# General Service Bulletin

**CVHE-SB-26**

**Subject: CVHE Oil Loss**

**Figure 1**  
**CVHE Vent Line and Vent-Line Solenoid**  
**Valve Location**

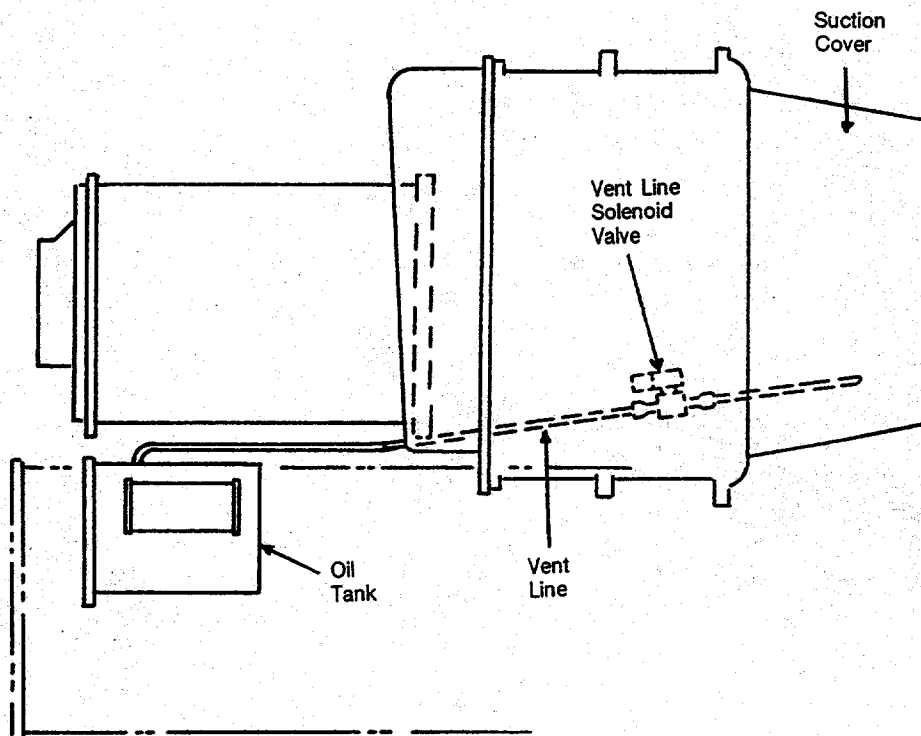
1a. Increase the vent line (Figure 1) size to 1-1/8". The line is 7/8" on units manufactured through September of 1990. Cut off the 7/8" line as close as possible to the oil tank and use a 1-1/8" x 7/8" reducing coupling. At the suction cover, cut the line and remove the screw-in fitting. Replace it with a 90-degree elbow (Mueller No. W2164) or straight adaptor (Mueller No. W1164), whichever is appropriate for the job. Both are 1-1/8" solder vs. 3/4" NPT. The bent tube in the old suction cover fitting is not required.

1b. Next, install a new ALCO vent-line solenoid valve (Trane Part No. VAL-3217) at the location shown in Figure 1.
